THIRD ANGLE PROJECTION:		APPROVALS	DATE		ADVANCED TECHNICAL MATERIALS, INC. TEL: (631) 289-0363 FAX: (631) 289-0358 www.atmmicrowave.com		THE INFORMATION IN THIS DRAWING IS PROPRIETARY AND SHALL NOT BE USED OR DISCLOSED WITHOUT THE PRIOR WRITTEN CONSENT OF ATM, INC. DO NOT SCALE DWG.	
UNLESS OTHERWISE NOTED, DIMENSIONS ARE IN INCHES, TOLERANCES ARE: FRACTIONS: $\pm 1/64$ ANGLES: $\pm 1/2^\circ$		DRAWN RL	05/12/06					
BASIC DIMENSION	DECIMALS 2 PLACE 3 PLACE	APRVD.		OUTLINE, CH235H-35 DIRECTIONAL COUPLER		SIZE A	REVISION D	
UNDER 6"	$\pm .03$ $\pm .005$	MATERIAL ALUM. BODY				CAGE CODE OR8N4	ATM DWG # 5047W	
6" - 12"	$\pm .04$ $\pm .010$	TREATMENT				SCALE 1 : 1	MODEL # CH235H-35	SHEET 1/1
OVER 12"	$\pm .06$ $\pm .015$	FINISH ATM STD. GREY

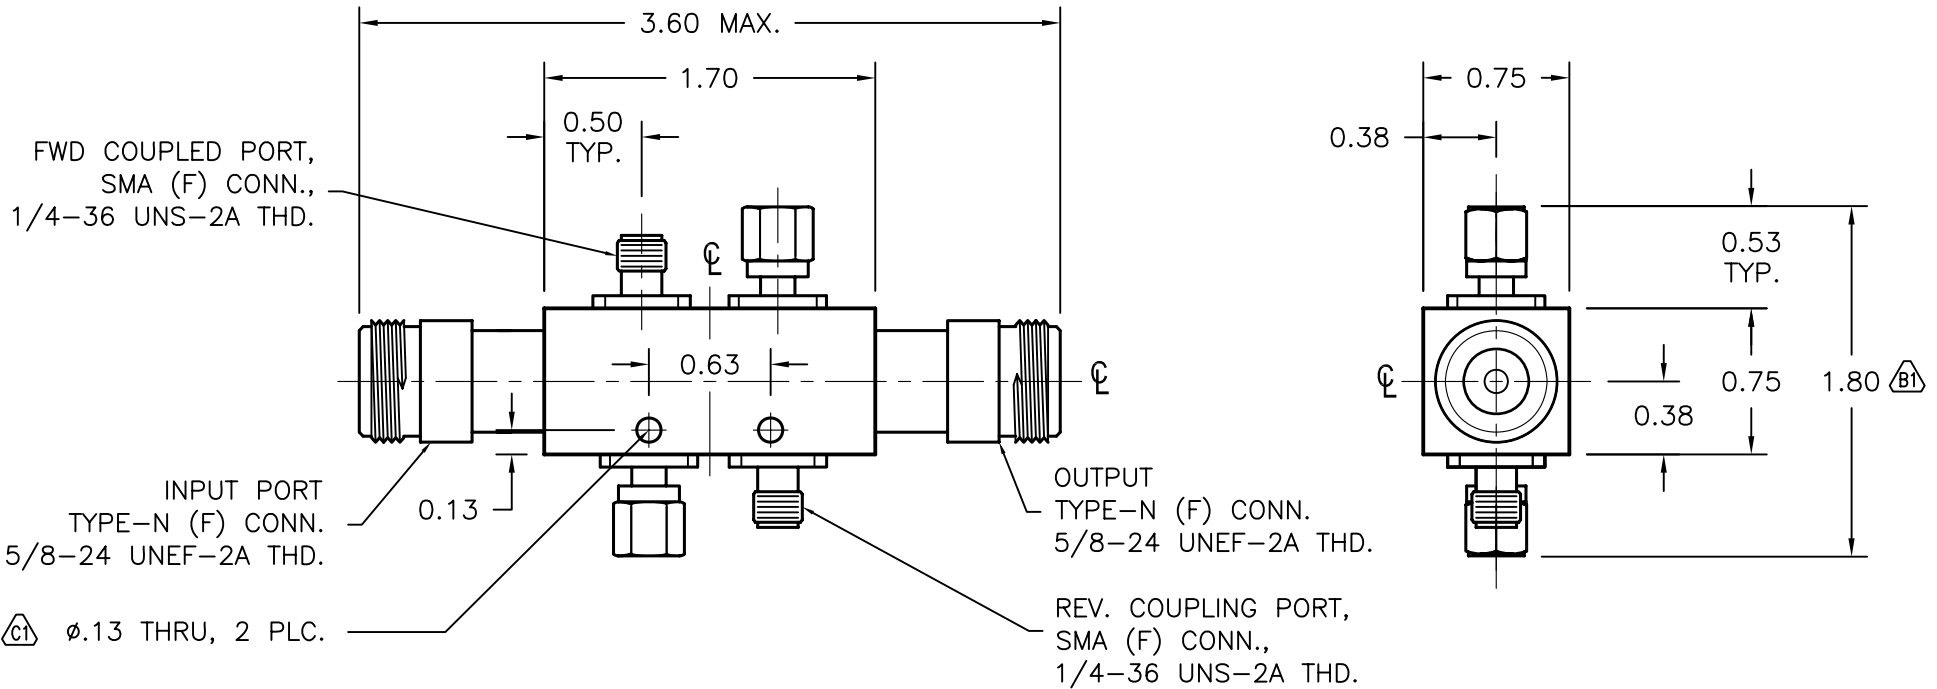
REV A	AUTH RL	DATE 07/22/02	INITIAL RELEASE
REV B	AUTH RL	DATE 05/12/06	REDRAWN TO SHOW SMA CONNECTORS AT COUPLED PORTS, WERE TYPE-N. $\triangle B1$ WAS: 2.75 MAX.
REV C	AUTH RL	DATE 11/13/06	MOUNTING HOLES CHANGED, WERE: #4-40 TAP x 4 PLC.
REV D	AUTH M.R.	DATE 8/20/10	MODEL# CORRECTED IN TITLE, WAS CHP235H-35
